INNER WEST COUNCIL

DEVELOPMENT ASSESSMENT REPORT

Application No.	DA201700003
Address	141-161 New Canterbury Road, Petersham
Proposal	To erect a mixed use development that includes partial retention of the existing industrial building with 2 commercial tenancies on the ground floor and 3 part 4 levels of residential units above with associated basement car parking
Date of Lodgement	4 January 2017
Applicant	Benson McCormack Pty Ltd
Owners	Peter Gabriel, Aziz Gabriel, Steve Gabriel, Kon Gabriel
Number of Submissions	38 submissions in total – 29 submissions during the original notification and 9 during the re-notification
Value of works	\$11,990,000
Reason for determination at Planning Panel	Clause 4.6 variation to maximum height standard, cost of development exceeds officer delegation, and number of submission received
Main Issues	Height of building
Recommendation	Deferred commencement consent

Image 1: Non-compliance with overall height at western elevation of Building ‘A’ – highlighted in red

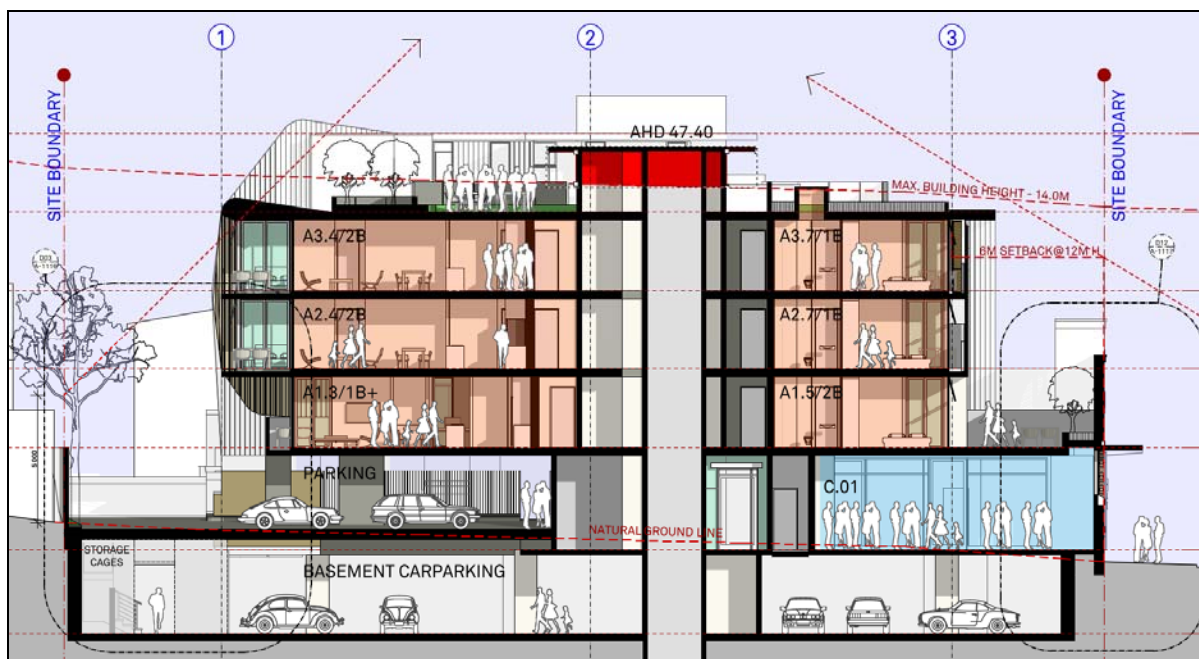
A maximum building height of 14 metres applies the site MLEP 2011. The development has a maximum building height of 17.9 metres which does not comply with the height development standard. The highest point of the development has a height of RL 49.40 AHD and thus results in a departure of 3.9 metres or 27.8% from the development standard.

- The degree of technical non-compliance with the 14m height limit is 2.44m, measured to the parapet of the lift overrun serving Building B. Deleting dwellings 4.1/3B and 4.2/3B will result in no change to the technical non-compliance because lift access to Level 4 is still required to enable equity of access to the roof terrace.

Image 3: Building height plane indicating non-compliant areas

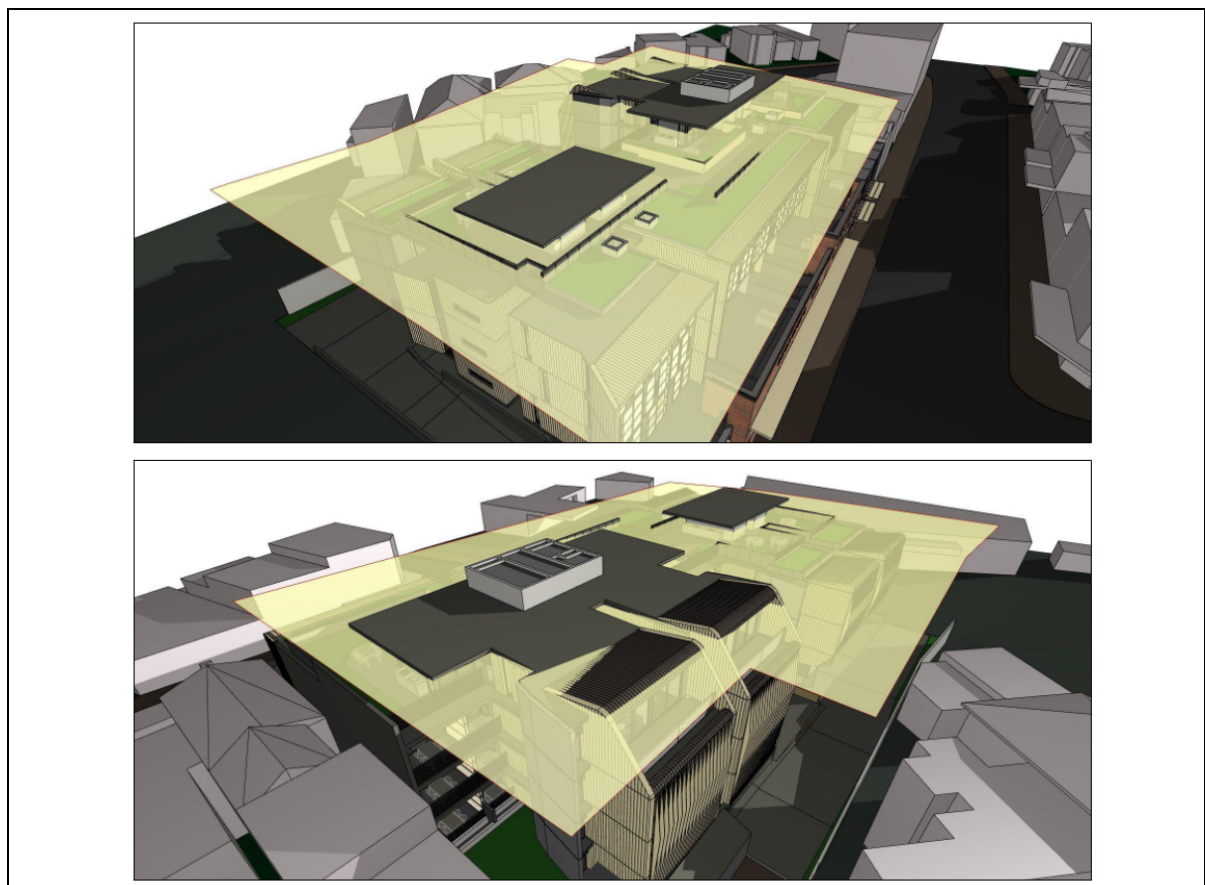
- The reason the NE corner of dwelling 4.1/3B complies with the maximum building height limit is due to the natural topography of this corner of the site (AHD34.63) being up to 3.96m higher than the SW corner of the site (AHD30.67). The change in topography is greater than a typical floor level and as such the stepped form of the proposed building envelope is therefore reasonable, particularly when viewed from the northern side.

Image 4: Amended Rear Building Envelope section – Building ‘A’

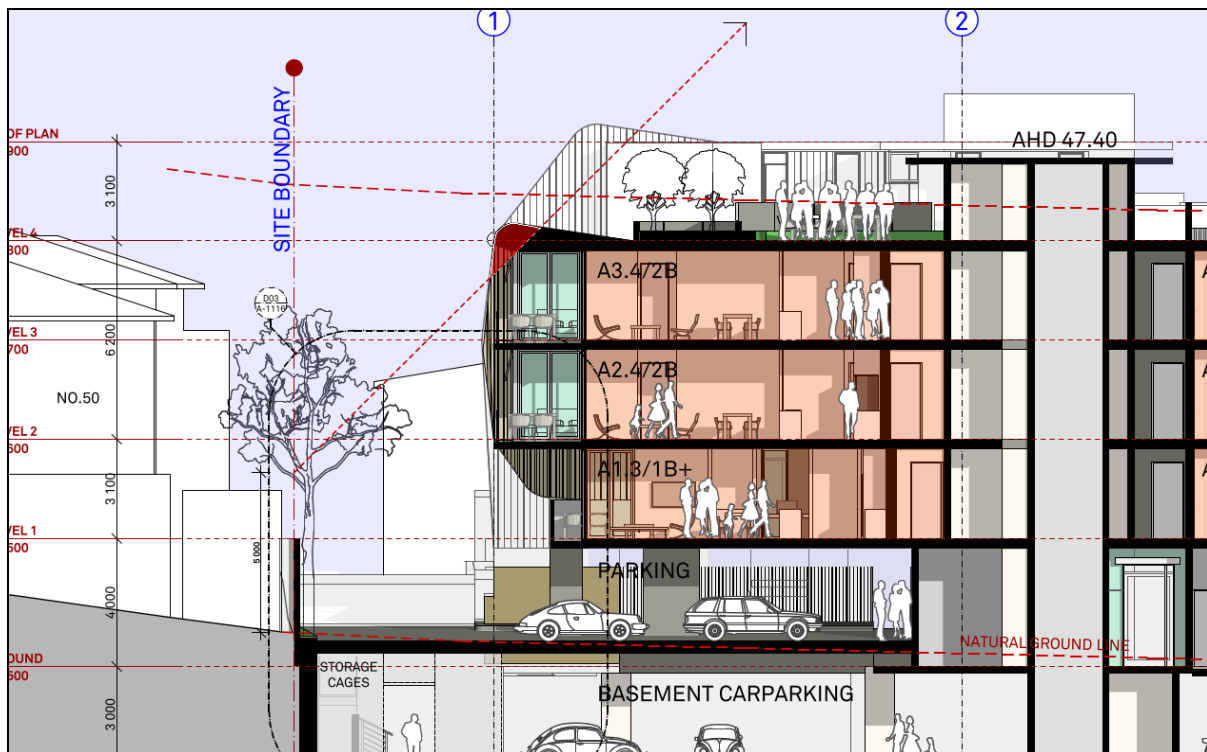
The rear building envelope is predominately contained within the rear boundary plane with a minor breach within the 45 degree sloping plane as shaded red in the partly reproduced sections below:

Amended Plans were submitted to Council on 13 June 2017 reducing the overall size of the rear architectural feature bronze cladding to reduce the extent of the non-compliance. The amended development generally complies with the rear building envelope as illustrated above. The extent of the breach includes a small portion of an architectural feature at the northern extent of the roof top level of building 'A' and the extent is negligible on building 'B'.
